Project #: 15630.00

Re: Response to Peer Review Letter #1 – Traffic Review
NOVO Riverside Commons
292-294 Baker Avenue
Concord, Massachusetts

VHB has received and reviewed the comments outlined in the November 6, 2023 Traffic Peer Review Letter from GPI on the proposed NOVO Riverside Commons development at 292-294 Baker Avenue in Concord, Massachusetts. The comments and our responses are provided below.

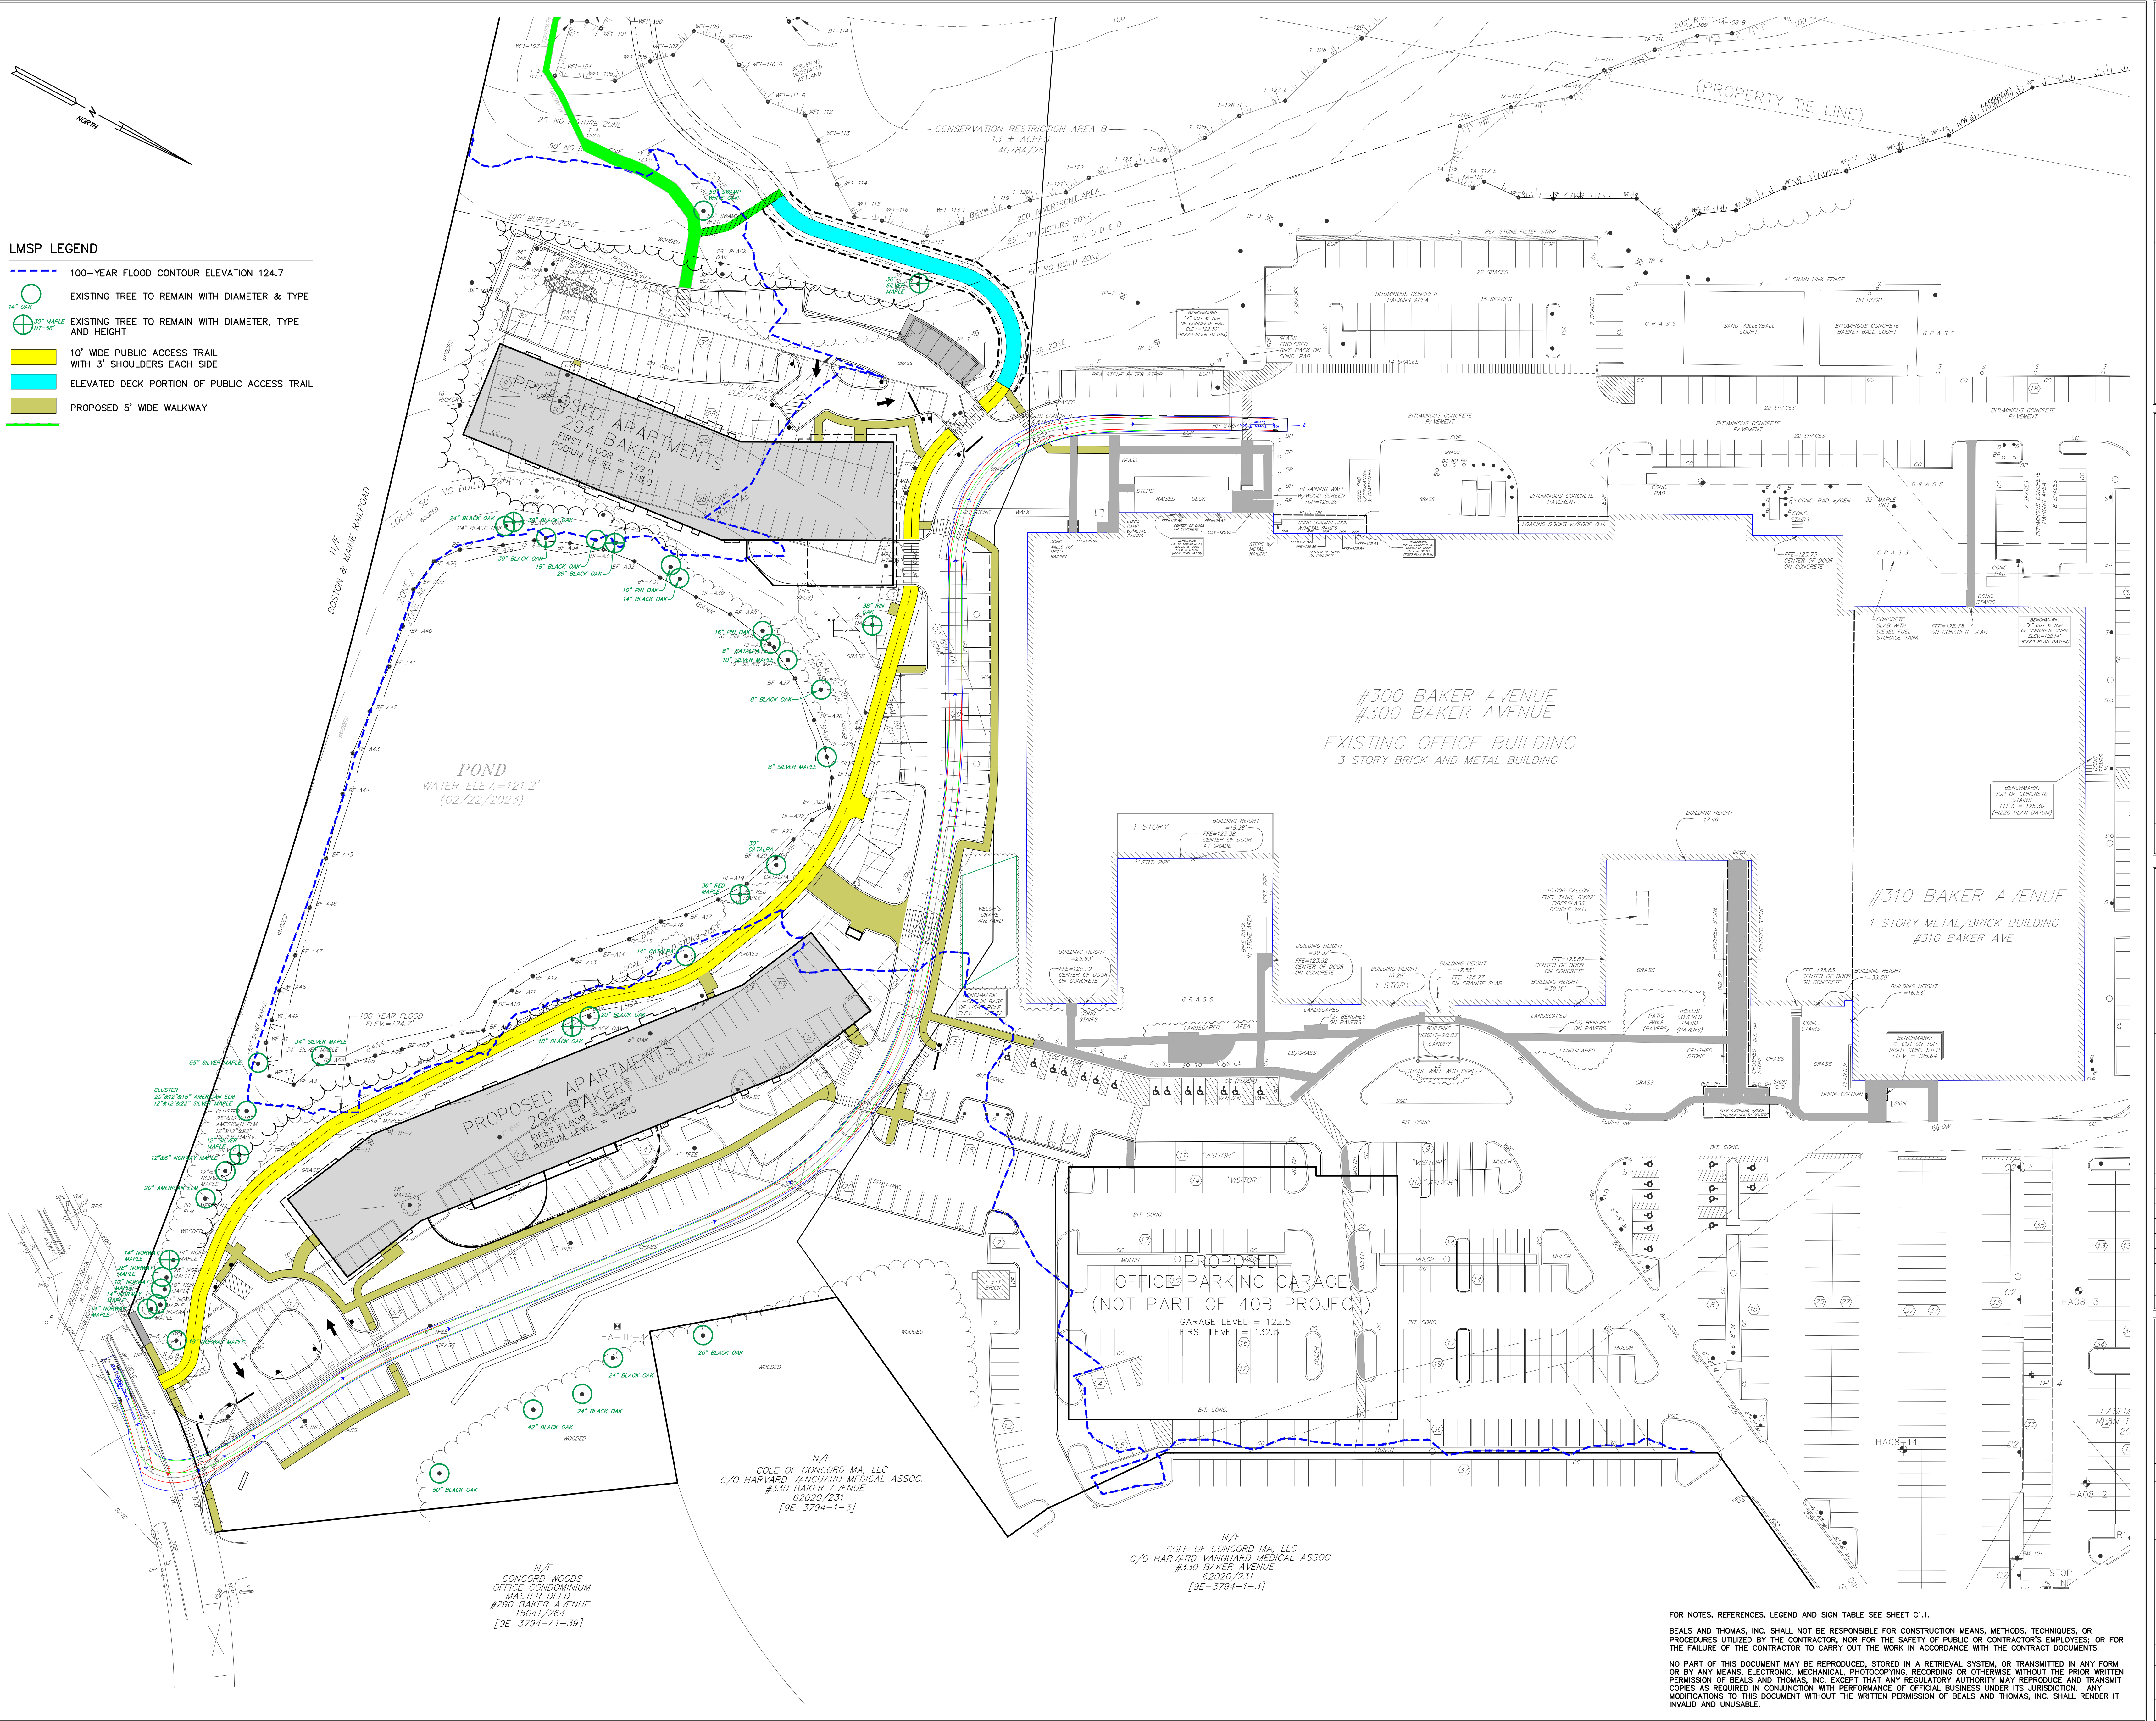
7. **The Applicant should provide vehicle turning path diagrams depicting the access and circulation of emergency vehicles, delivery vehicles, and trash removal vehicles for the site.**

Response: We have prepared vehicle turning path diagrams for emergency vehicles, delivery vehicles, and trash removal vehicles, and have included as exhibits to this document.
